August 20, 2018
BOARD OF COUNTY COMMISSIONERS
ORANGE COUNTY, FLORIDA
Addendum No. 1, IFB Y18-789-EB
BARBER PARK PLAYGROUND IMPROVEMENTS

Bid Opening Date: August 30, 2018

CONSTRUCTION PLANS FOR ORANGE COUNTY PARKS & RECREATION BARBER PARK PLAYGROUND IMPROVEMENTS DISTRICT NUMBER 3 ORANGE COUNTY, FLORIDA

PLAYGROUND LAYOUT & COMPONENTS

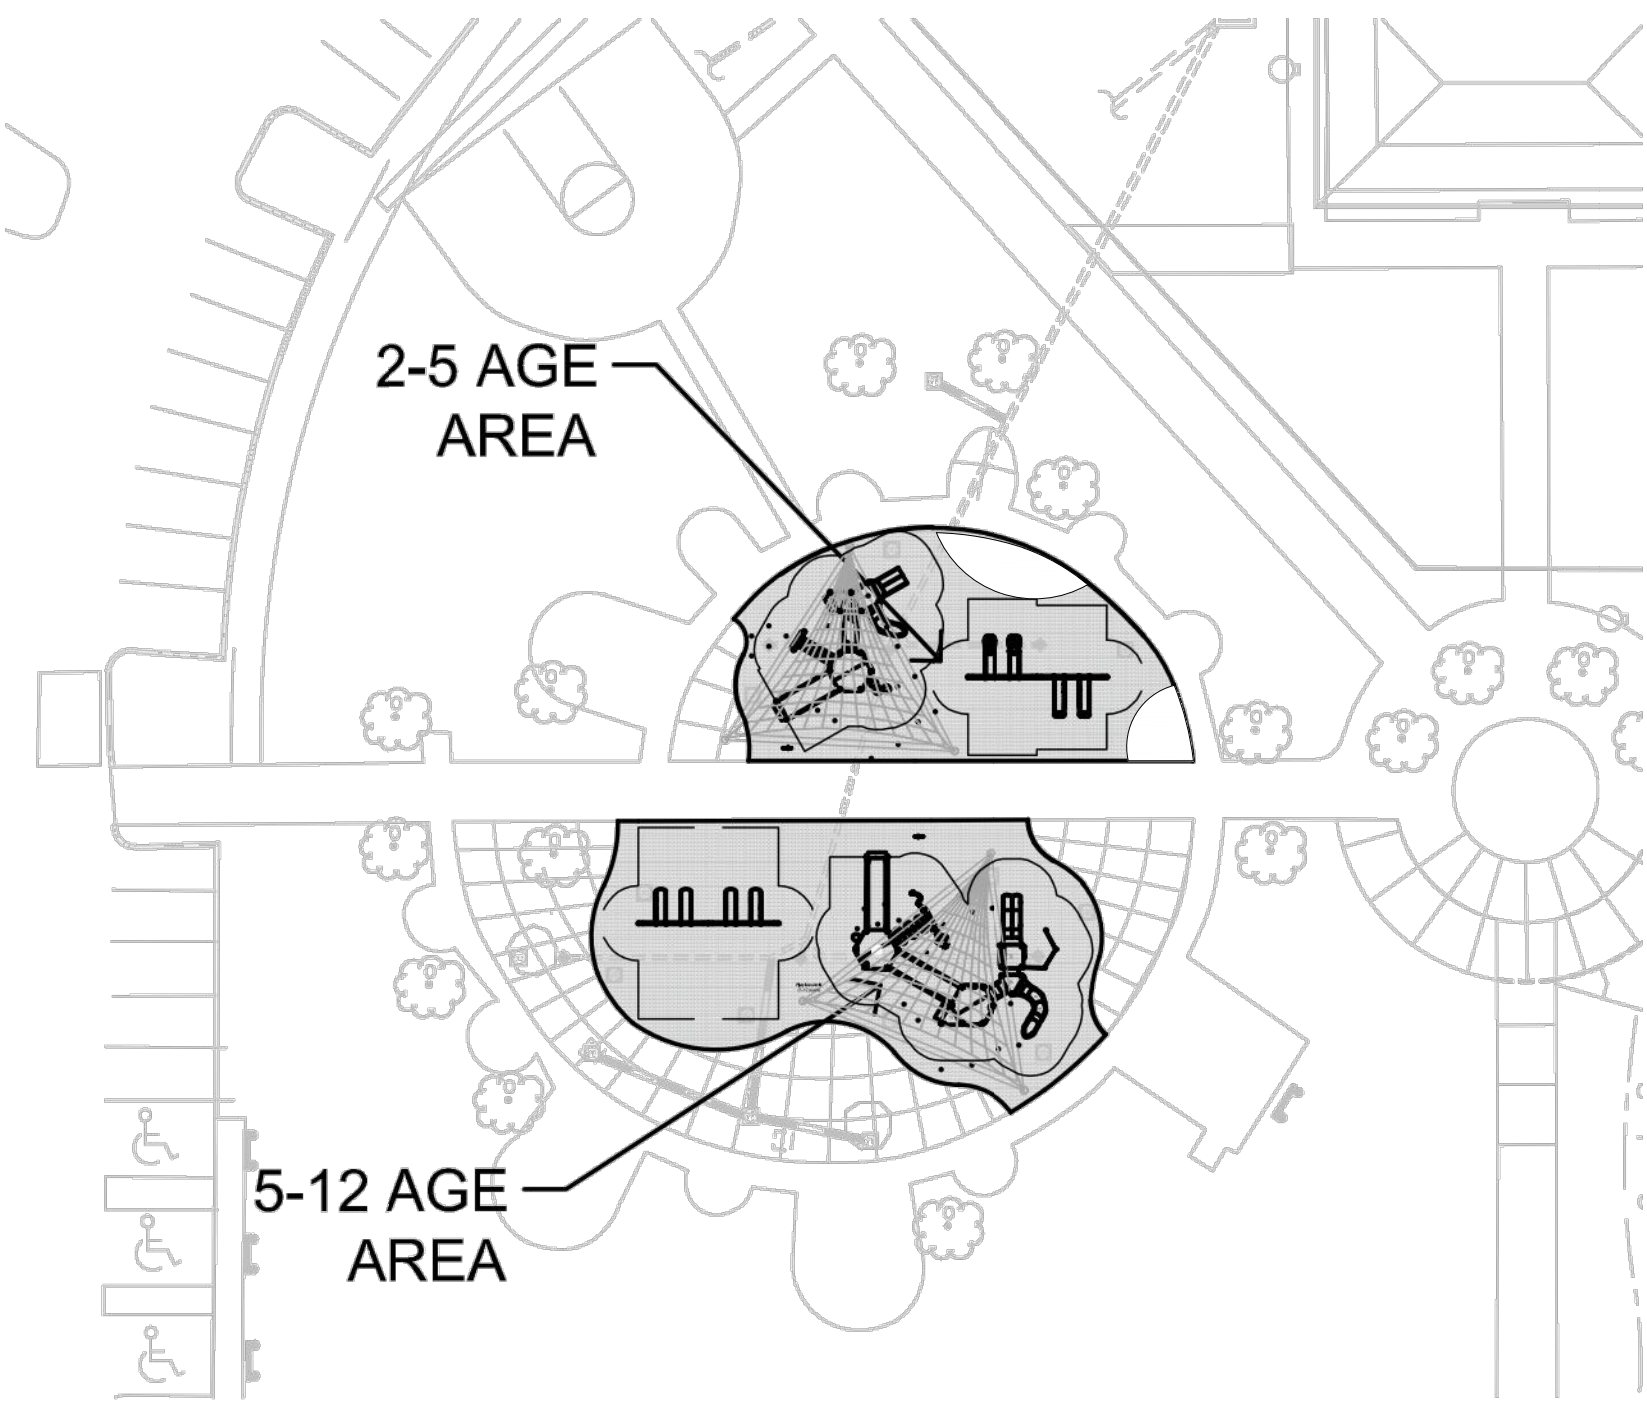
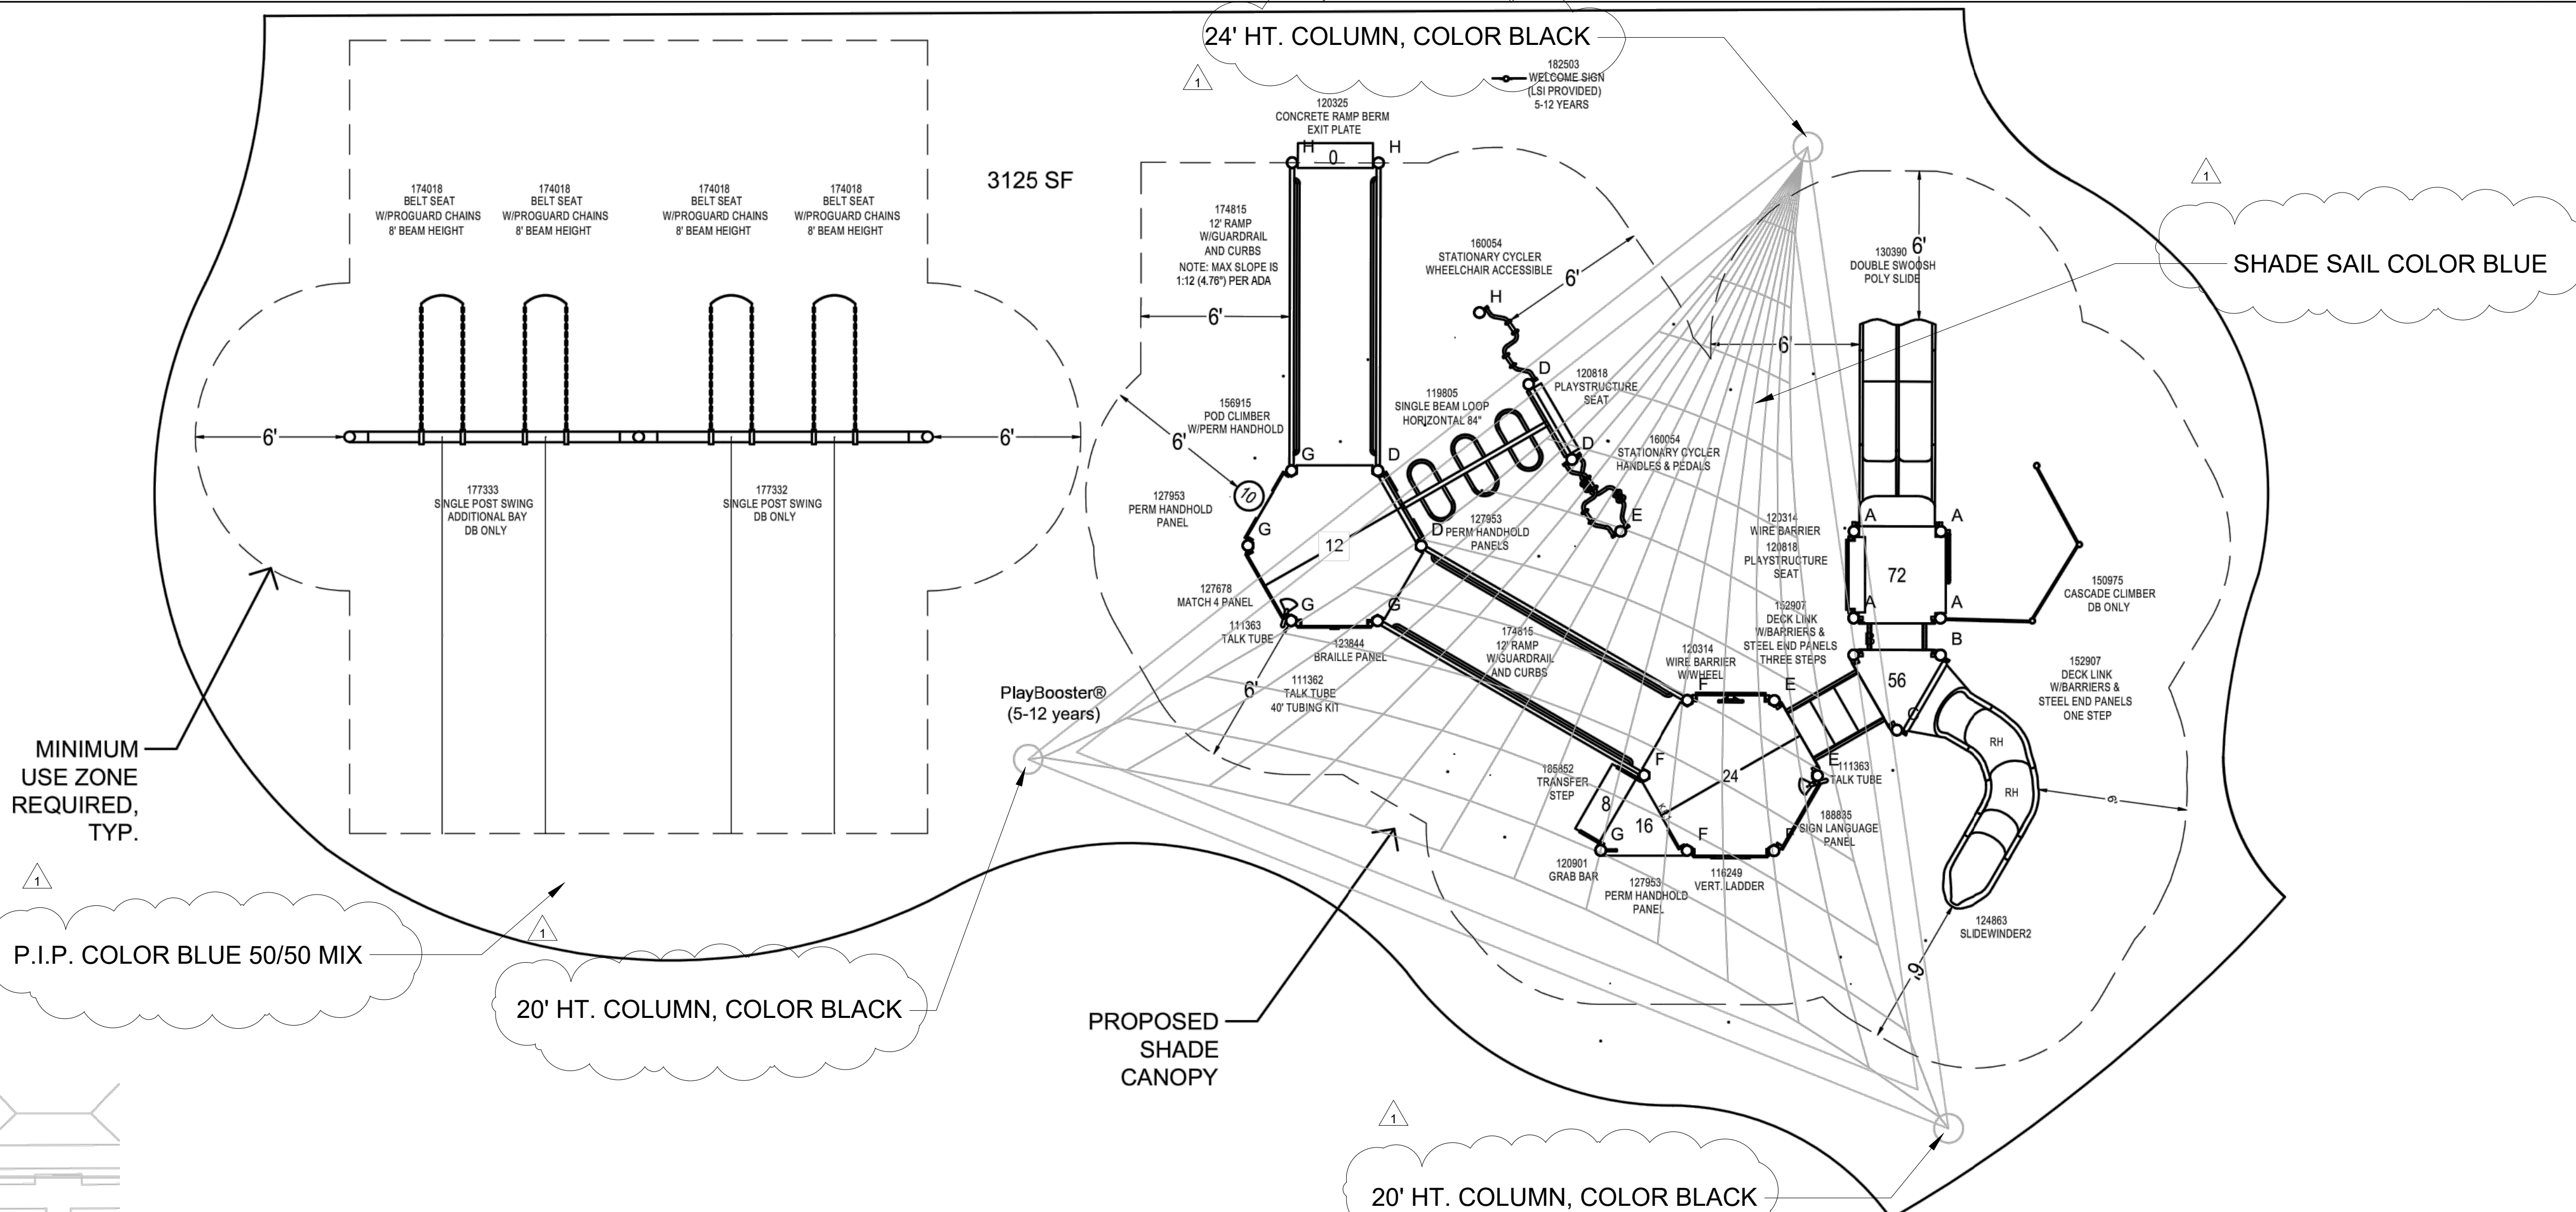
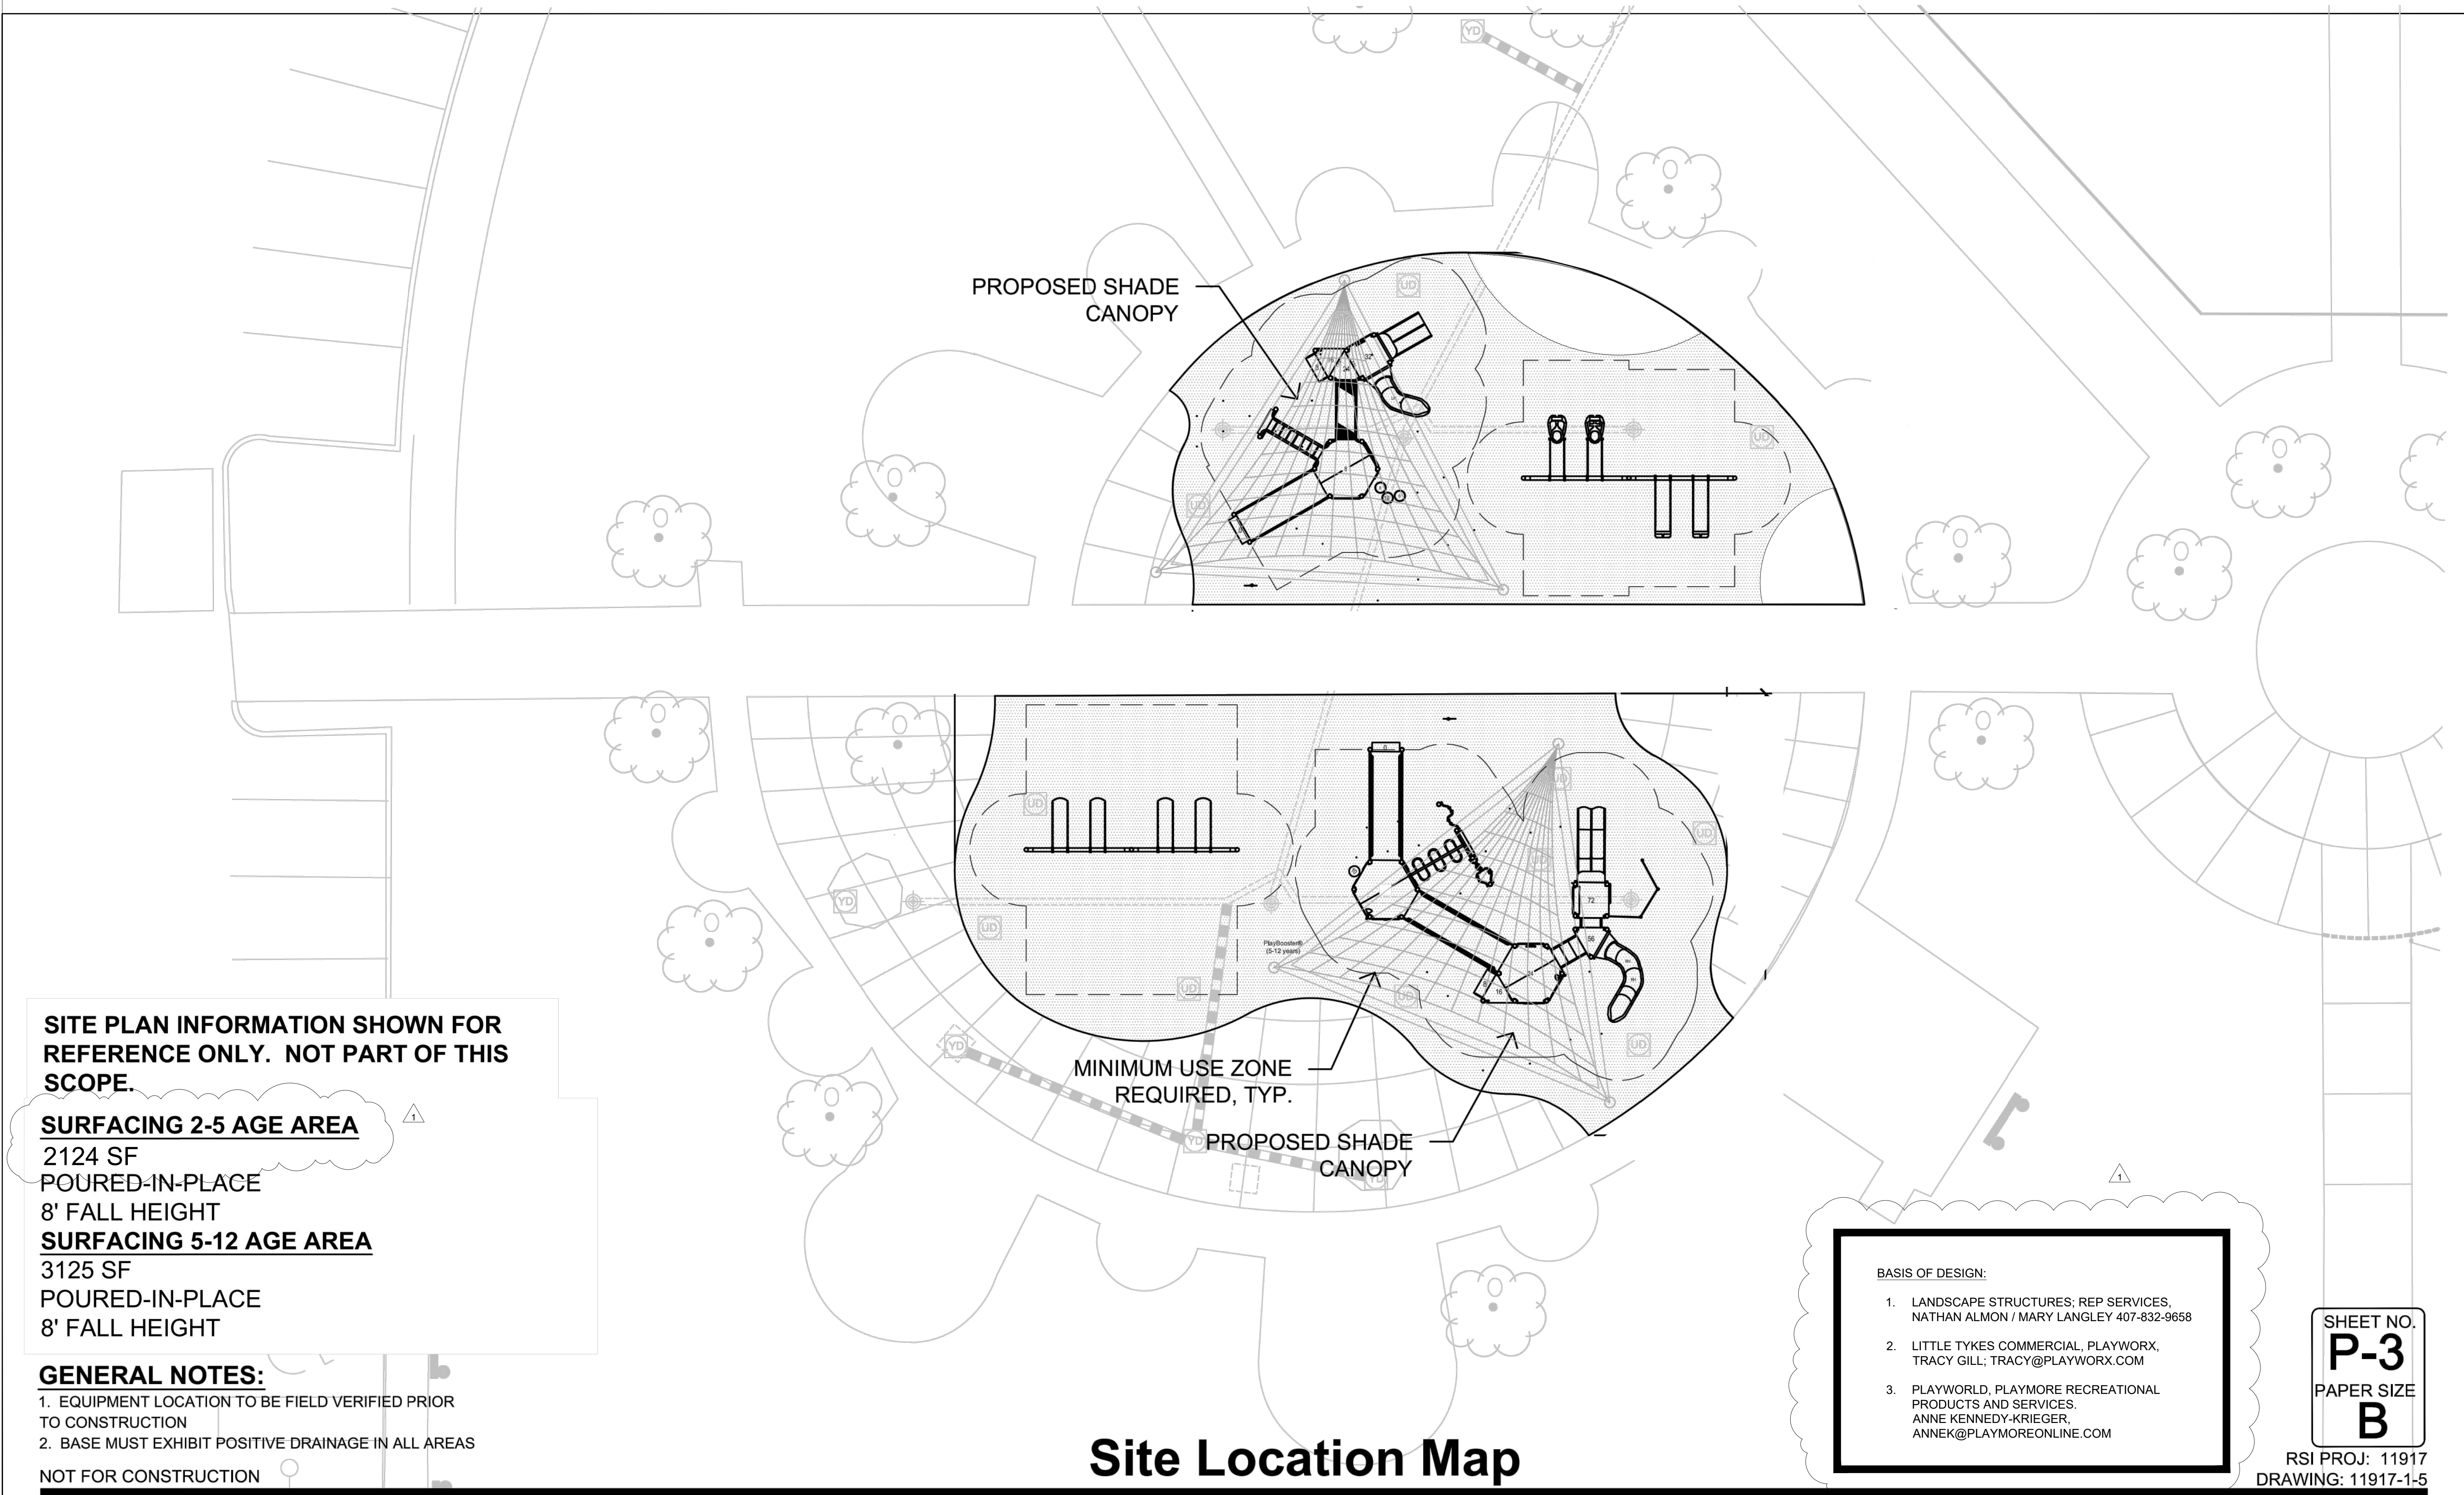
- Shade sail color added
 - Column height and color added
 - Basis of design added
- Sheet P.3 Playground Layout & Components
 - Dimensions removed
 - Safety Surface area revised
